Memorandum

FROM: Hayes Taylor, City Planner

DATE: January 26, 2026 *(Amended February 3, 2026)*

CASE: **2025-CD-RZ-06**

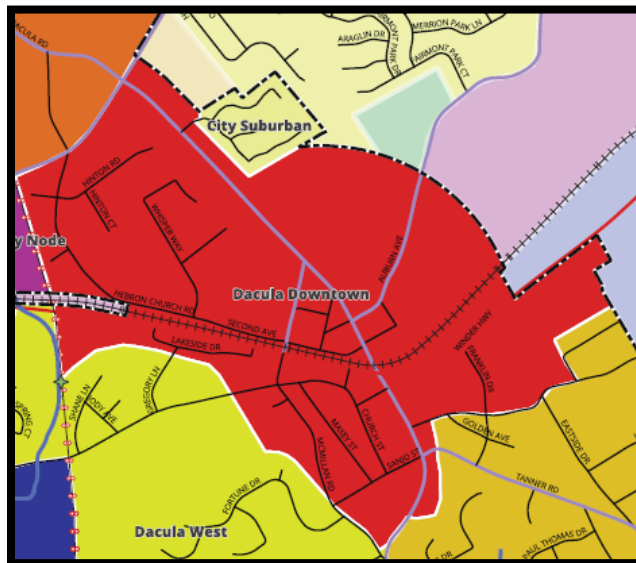
The rezoning request could be considered compatible with the nearby commercial and residential uses, if adequate screening is provided. The proposed infill project could provide a transition from more auto-oriented uses at the intersection of Winder Hwy and Harbins Rd, and the legal-nonconforming gas station to the pedestrian friendly, town-center development pattern within the nearby Dacula City Core area.

The submitted concept plan complies with the intent and purpose of the DOD. The proposed infill development’s access drive provides an opportunity to decrease the number of curb cuts along Harbins Rd within the downtown area, should the adjacent parcel to the north redevelop. Fewer curb cuts would result in fewer opportunities for automotive sidewalk crossings, allowing residents to utilize the 8 ft pedestrian sidewalk with fewer interruptions. The parking lot plan complies with the parking standards outline in the DOD, including number of parking spaces per square foot, its orientation, the inclusion of green

stormwater infrastructure, and the preservation of mature growth trees when feasible. The screening requirements between residential and commercial uses within the DOD provide a visual separation and privacy for residents.
